SUNDRY NOTICES AND REPORTS ON WELLS
Do not use this form for proposals to drill or to re-enter an abandoned well. Use form 3160-3 (APD) for such proposals.

8. Well Name and No.
EMSU 262H

XTO Energy, Inc respectfully requests to change the liner system in the referenced well with the following procedure:

**EMSU 262H
30-025-04454
Matador Production Company
February 05, 2016
Conditions of Approval**

PROPOSED
EUNICE MONUMENT SO. UNIT #262H
 SHL: 661' FSL & 663' FWL
 BHL: 3080' FSL & 2160' FEL
 SEC 3, T21S, R36E
 LEA CO, NM
 API# 30-025-04454
 SPUD: 11/1/35
 COMPLETION: 10/18/36

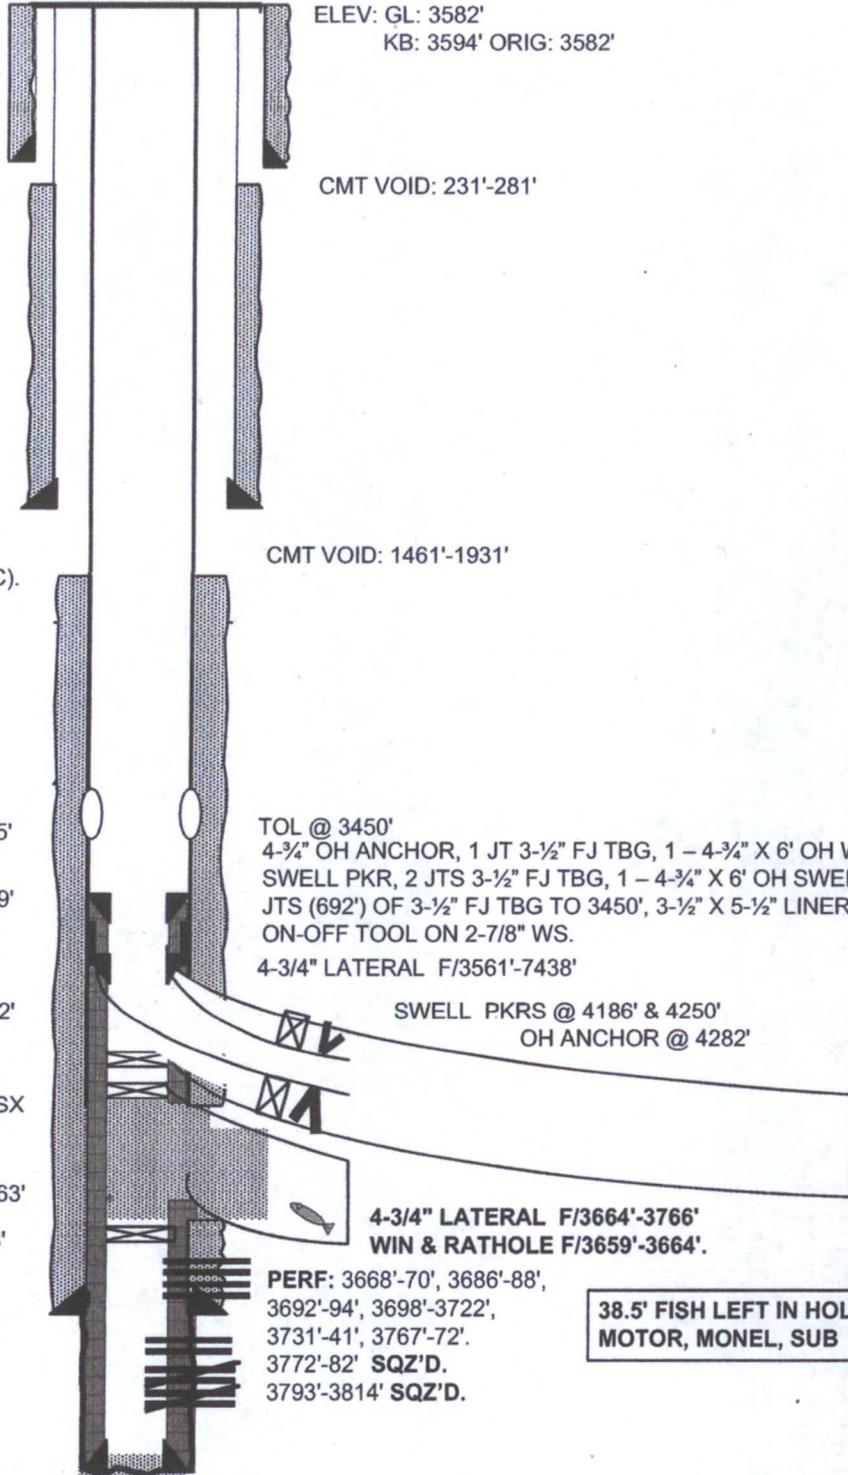
Liner Specifications:

New 3-1/2", J-55, 9.3#, FJ liner set from 4,282' ? 3,450' MD in 4-3/4" open hole.

A proposed wellbore diagram is attached.

- 1. Liner system change approved.**
- 2. Must conduct a casing integrity test before perforating and fracturing. Submit results to BLM. The CIT is to be performed on the production casing to max treating pressure. Notify BLM if test fails**
